RE: Petition No. 1226
Towantic Switching Station and Line Modification Project
Structure 1496A Relocation

Petition No. 1226 Towantic Switching Station and Line Modification Project - *Structure 1496A Relocation*

TOWANTIC SWITCHING STATION AND LINE PROJECT

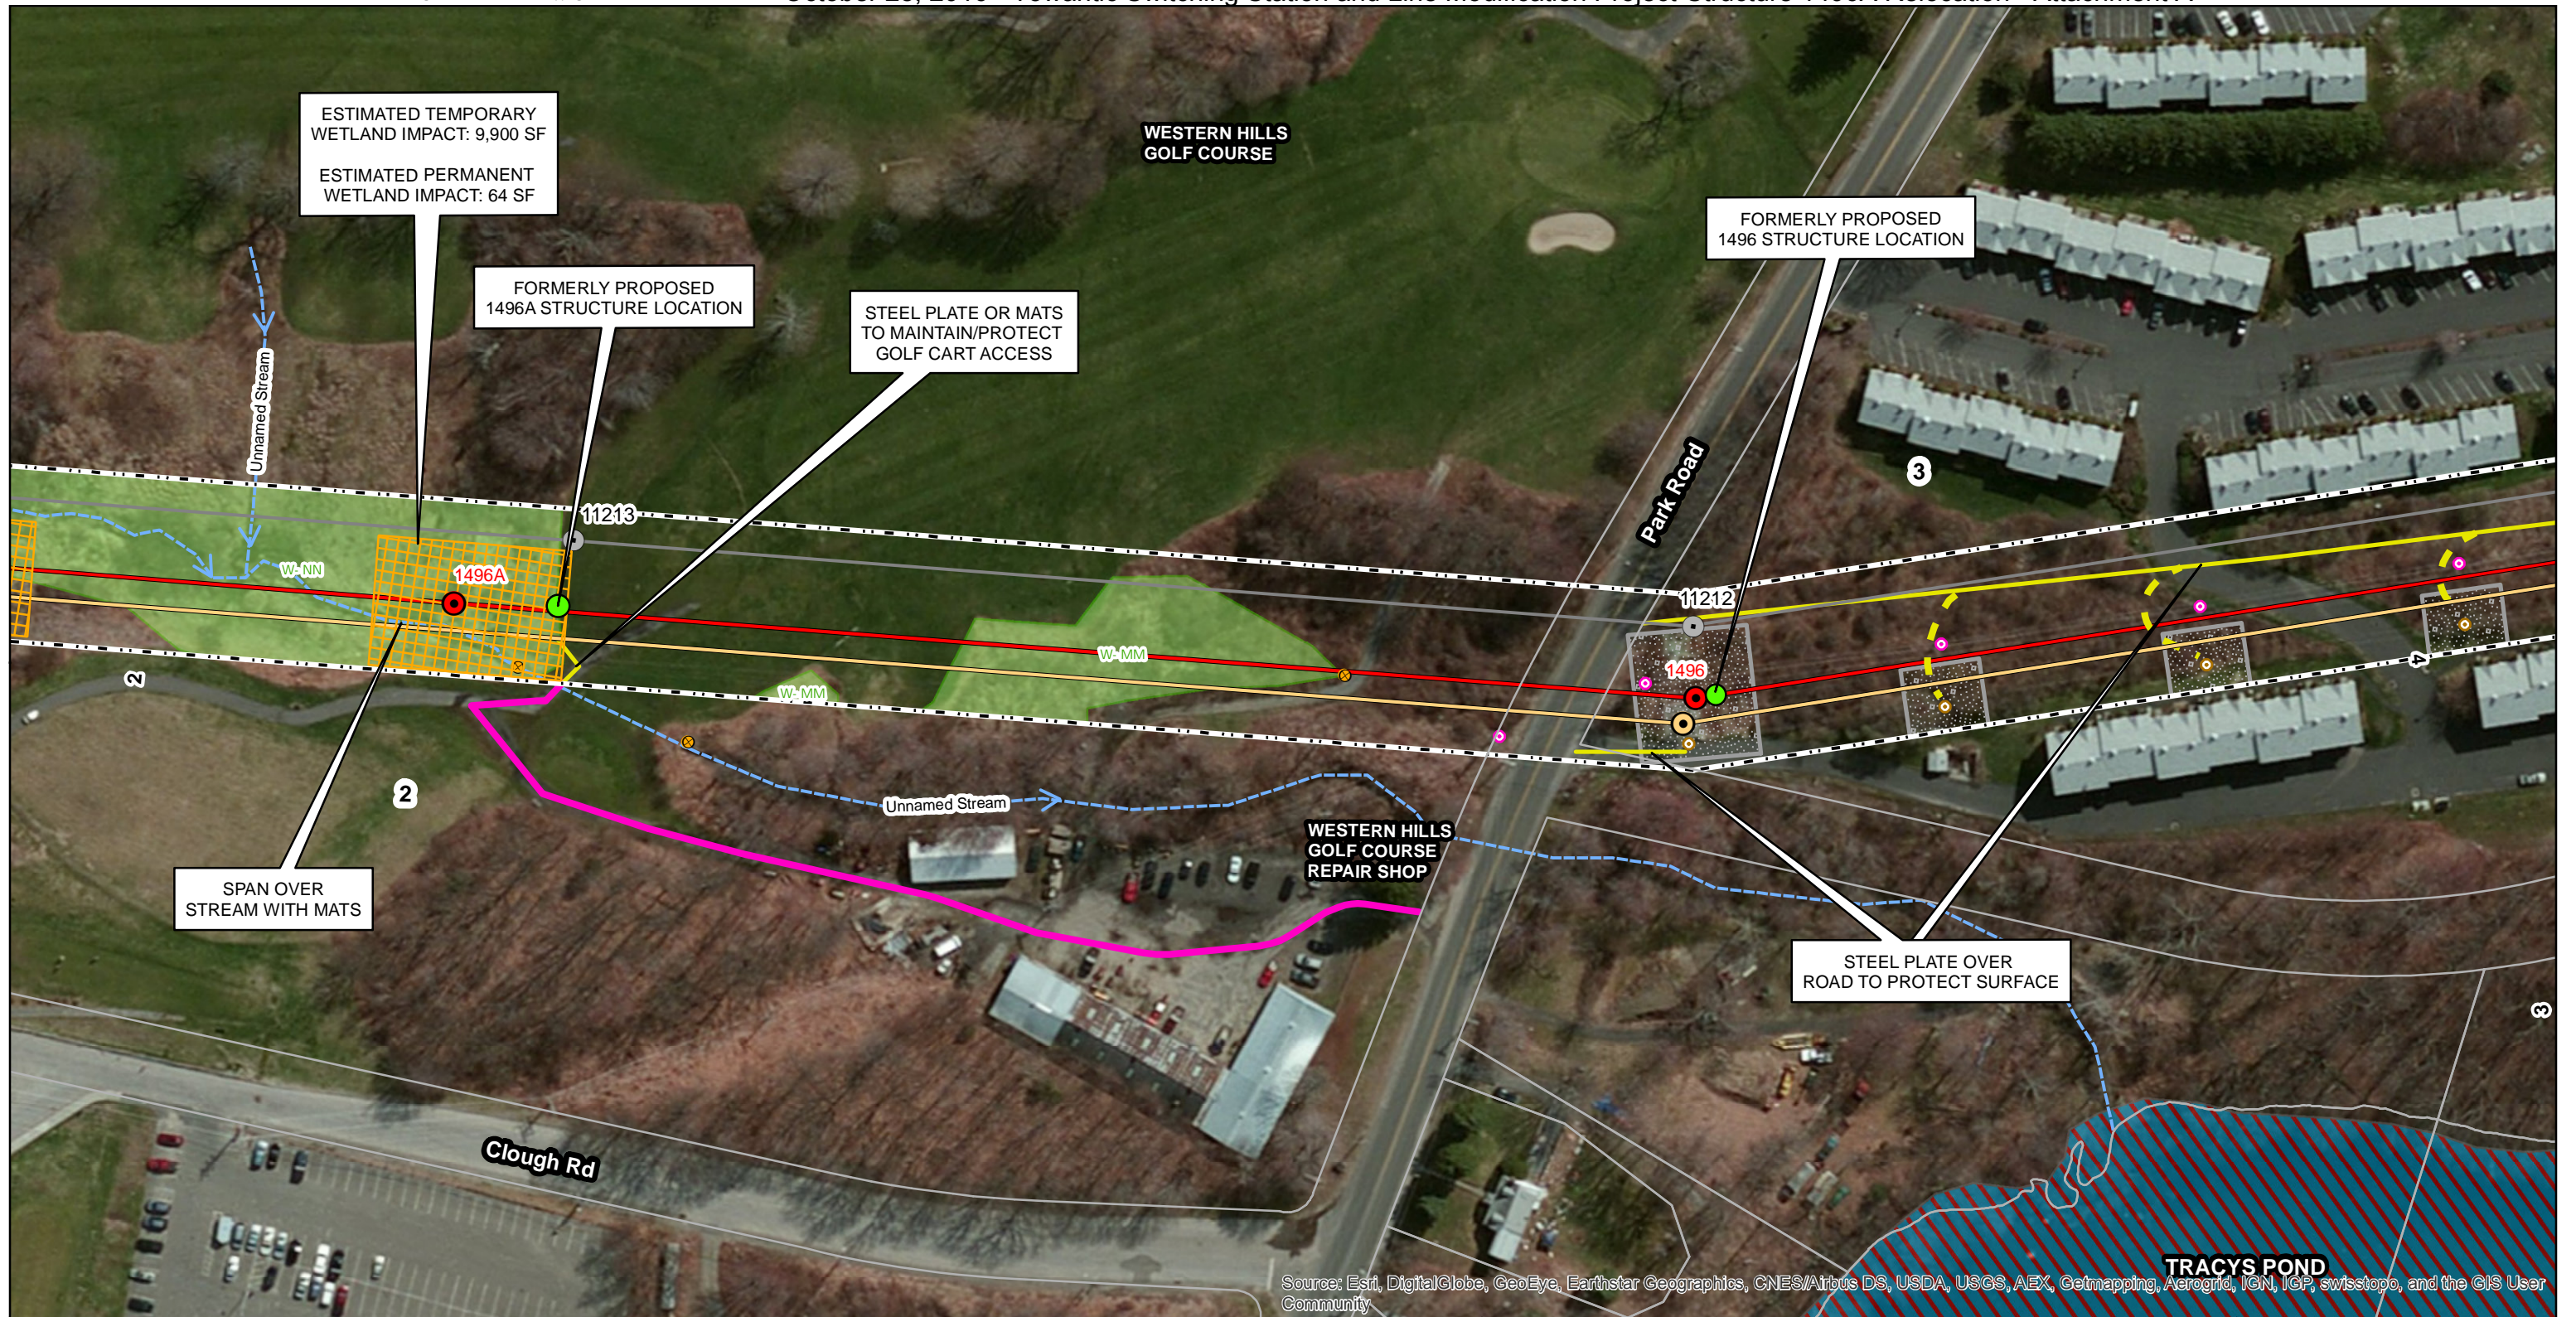
Condition 10 of the Council’s ruling requires Eversource to “coordinate work to minimize the impact on the Western Hills Golf Course” (“WHGC”). Accordingly, Eversource met with Mark Lombardo, Waterbury’s Supervisor of Parks & Golf Course on May 24, 2016 to review the impact of the Project on WHGC and, in specific, the location of Structure 1496A, which is the only new structure proposed to be located within the boundary of the WHGC. The original proposed location of this structure was within close proximity to the fairway and within the area of play. WHGC requested that this structure be moved, to the extent possible, and it was agreed that moving it sixty (60) feet to the north would minimize the impact on the WHGC. The proposed relocation is depicted on the revised mapsheet that is provided in Attachment A (Towantic Switching Station and Line Project Page 3 of 26).

You will note that by moving Structure 1496A as depicted in the attached Attachment A, the temporary wetland impact increases from 5,788 SF to 9,900 square feet, but since there are no changes to the structure’s foundation, the permanent wetland impact remains at 64 square feet. As was proposed for construction at the original location of Structure 1496A, Eversource will employ the same square footage of construction mats and will span over the stream with mats and will use steel plates or mats to maintain/protect golf cart access.

Eversource herewith respectfully requests the Council's approval for the relocation of Structure 1496A. Enclosed please find an original and 15 copies of this submission. Should you, the Council members or Council staff have any questions regarding this request, please do not hesitate to contact me via e-mail at kathleen.shanley@eversource.com or telephone at (860)728-4527.
